# UNITED STATES PATENT AND TRADEMARK OFFICE

10/534,837

Manfred Piontek

# Office Action Summary

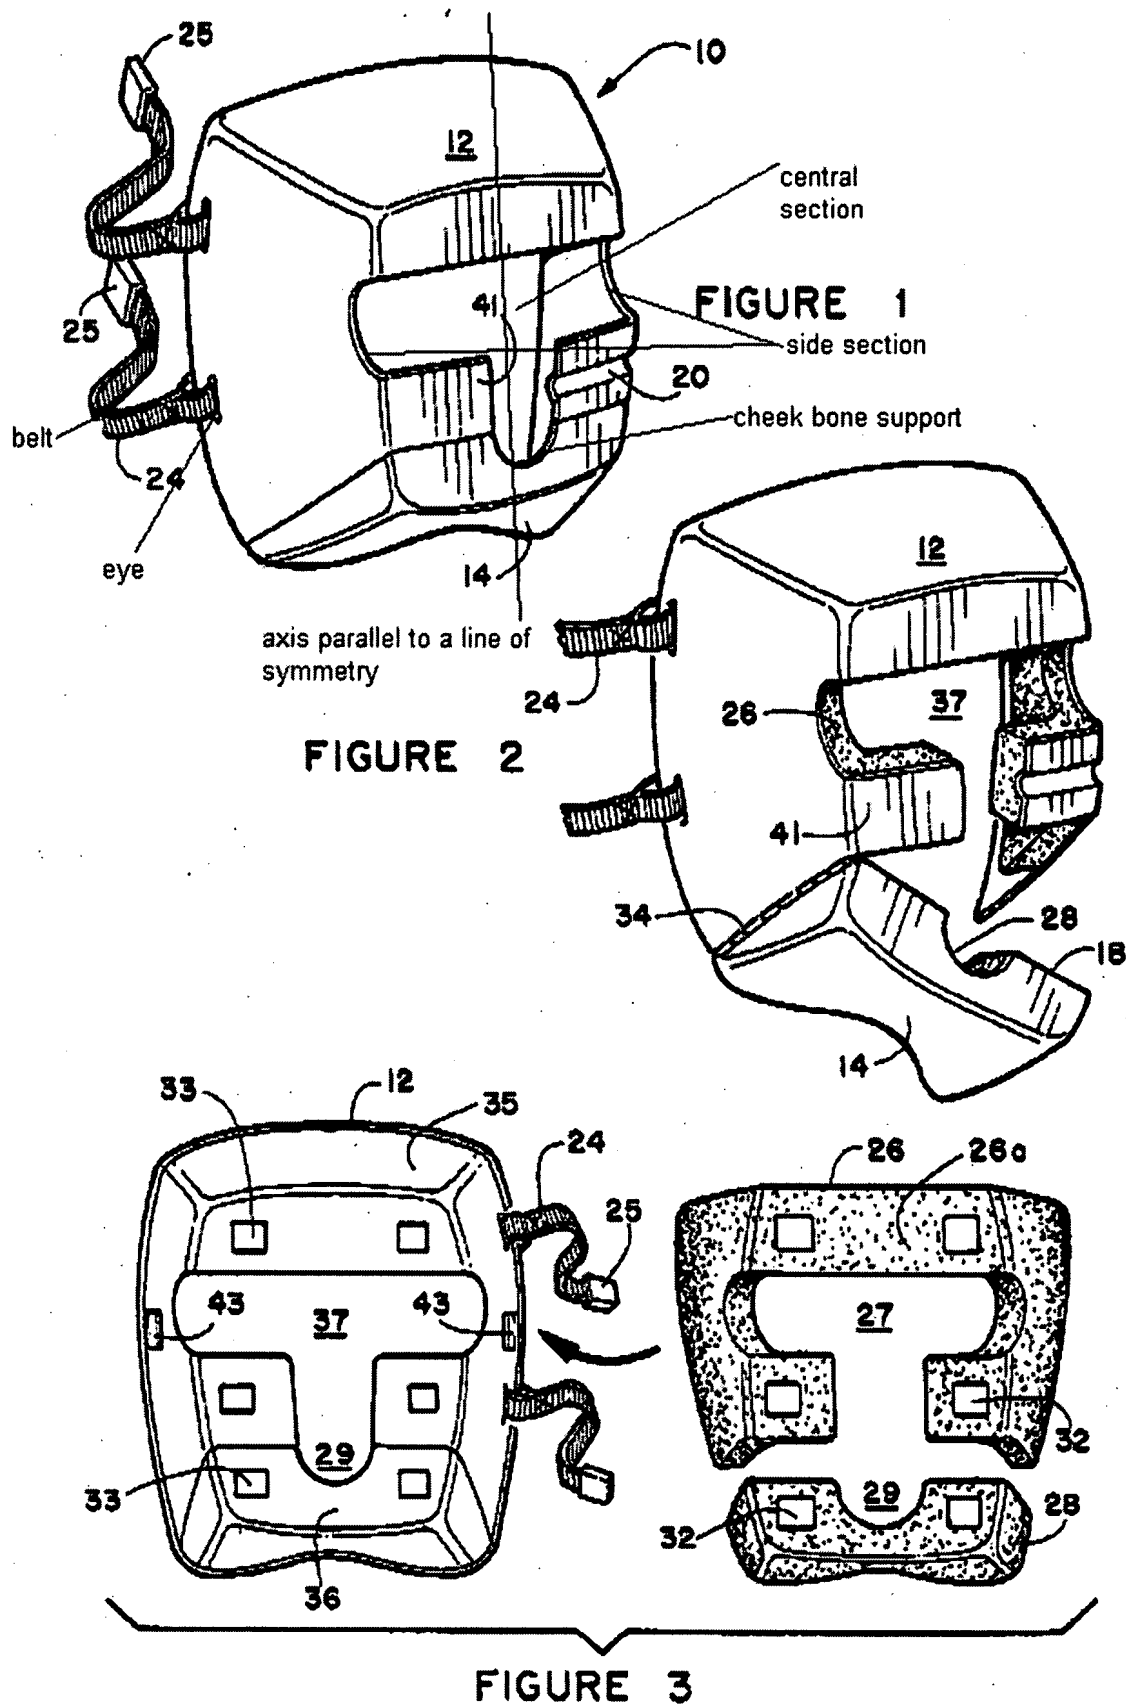
the rest shell has an approximately horseshoe-shaped (see fig 1) form with a central section (37) for supporting the rear or forehead of a head, which central section (37) has a support surface of approximately spherical shell shape, and with two side sections conform at least approximately to a common cylindrical surface whose axis runs parallel to a line of symmetry of the head support running between the side sections with there being a cheekbone (14) on each of the side sections which cheekbone support projects in the direction toward the other side section (see figure below).
